WILLINGTON PUBLIC SCHOOLS
REQUEST for QUALIFICATIONS/PROPOSAL
For ARCHITECTURAL SERVICES

HALL MEMORIAL SCHOOL AND CENTER ELEMENTARY SCHOOL
ROOF REPLACEMENT PROJECTS

Addenda #1 2-25-2021

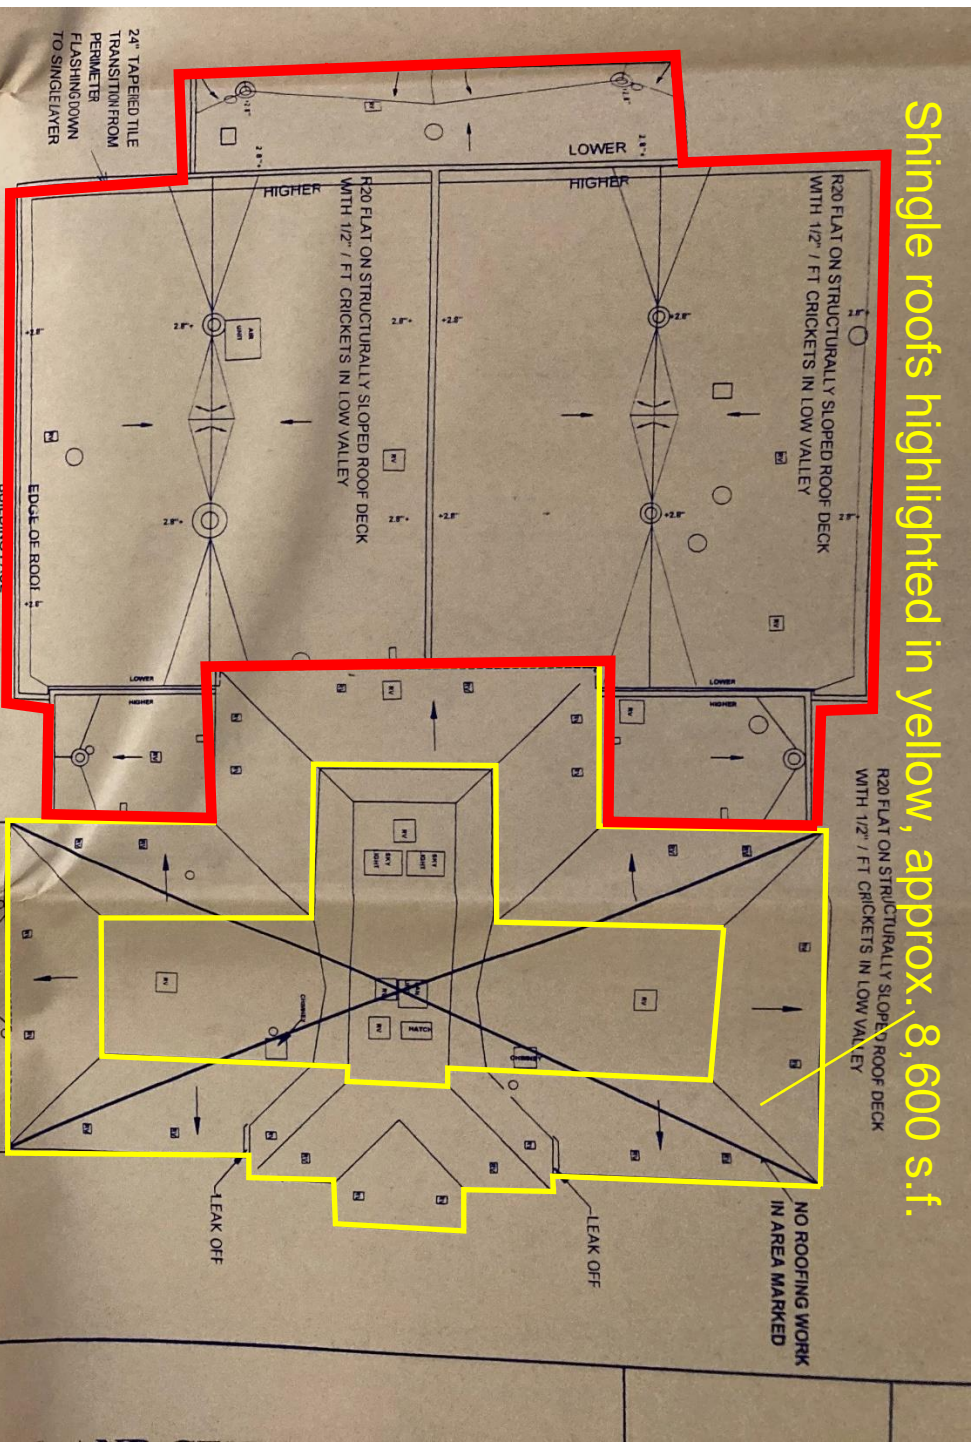
Shingle roofs highlighted in yellow, approx. 8,600 s.f.

Note: construction documents including structural framing plans and details exist for the area highlighted in red.

INSULATION PLAN

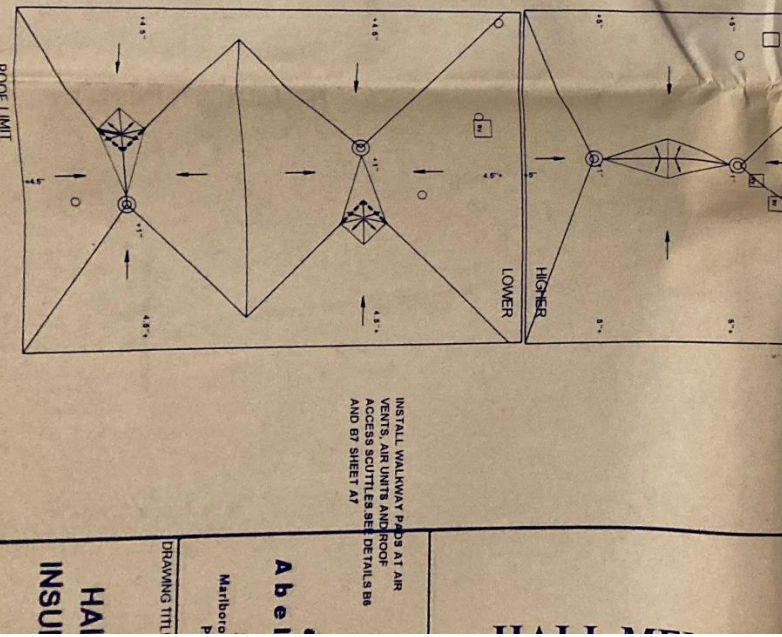
All roof areas will be replaced by this project. Previous replacement in 1997 State Project # 160-027RR Shingle area approx. 8,600s.f. Membrane roof area approx. 26,600 s.f.
